Re: Design Exception #25-07 – Mountain Cement Company

DESIGN EXCEPTION REQUEST 25-07

Project: Mountain Cement Facility

EXHIBIT A

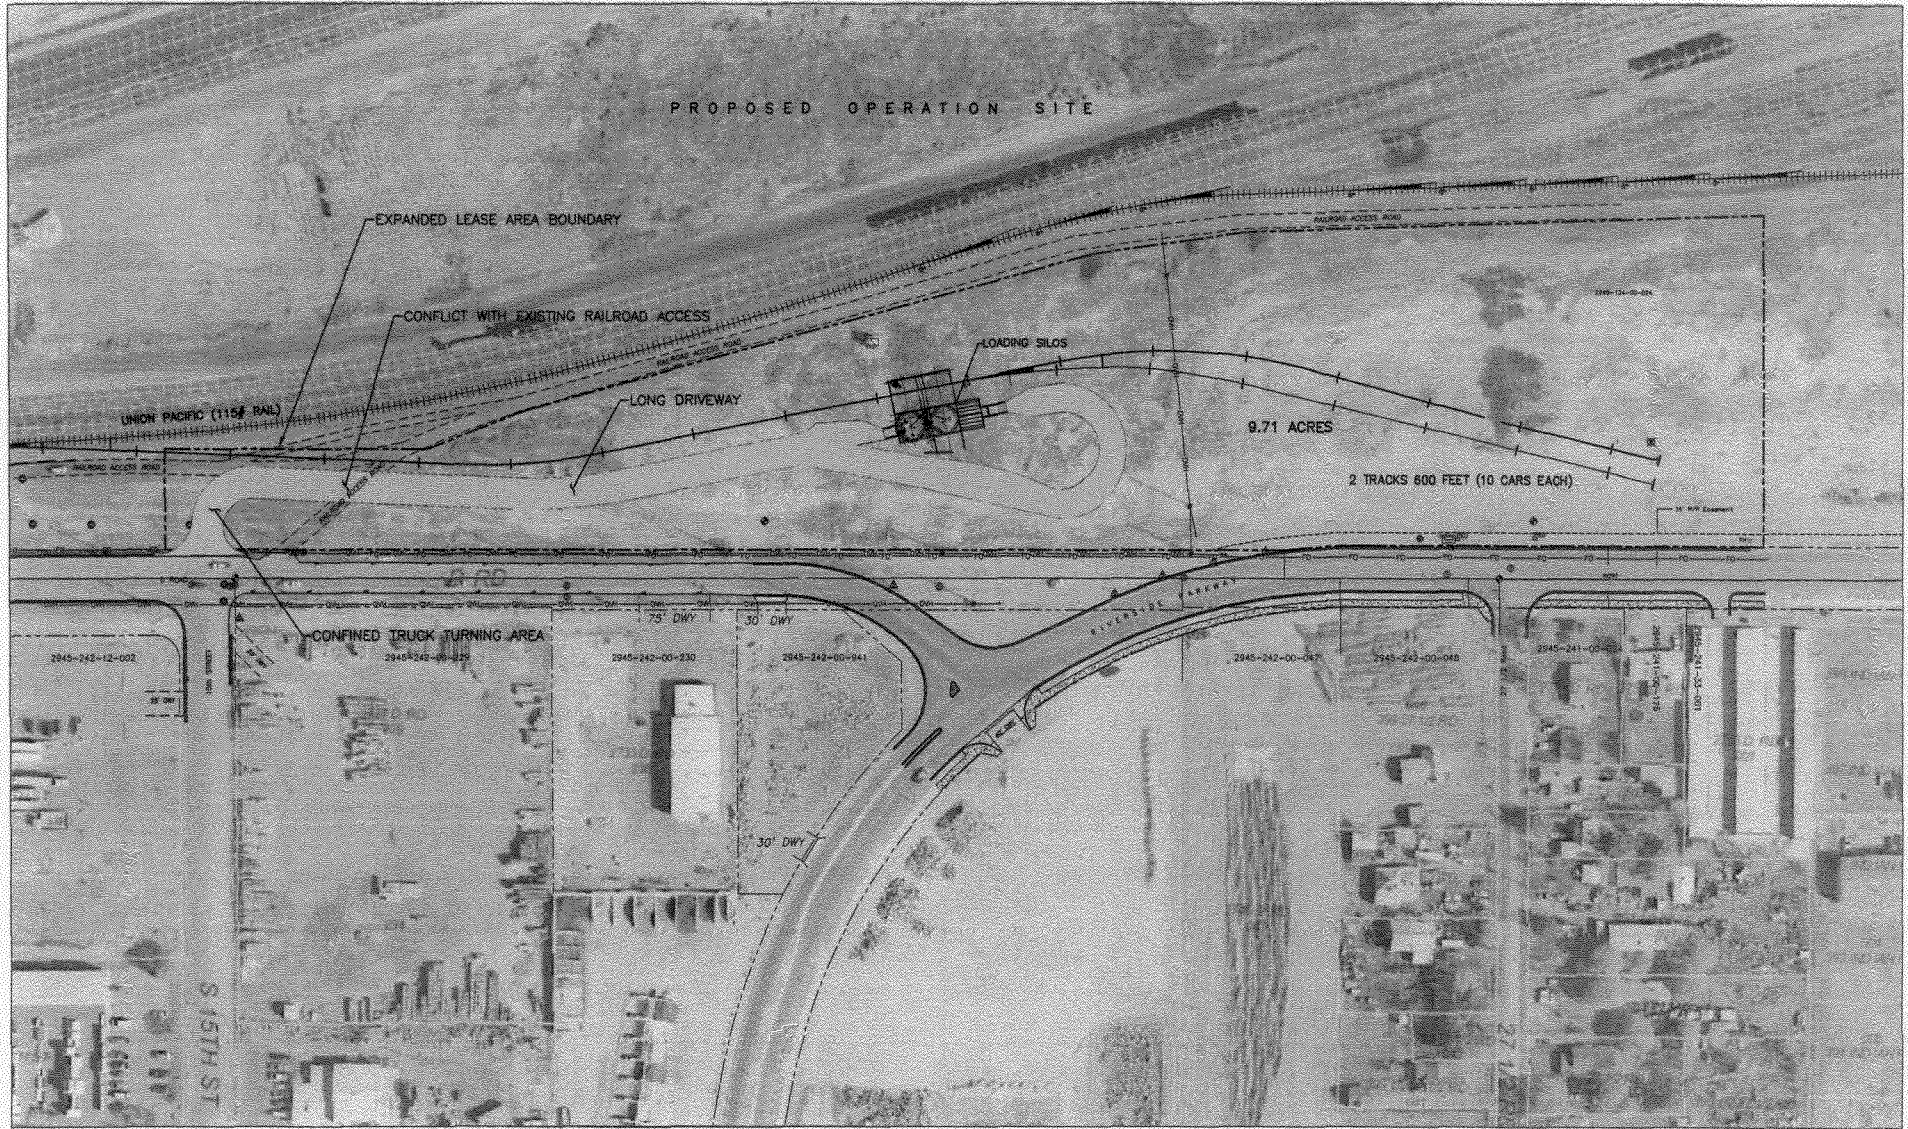
As discussed above, the other alternative considered (Exhibit A) would meet the driveway spacing and alignment criteria but causes hardships in the areas of distance to loading facility, conflict with existing UPRR access roads and more confined semi-truck turning movement area.
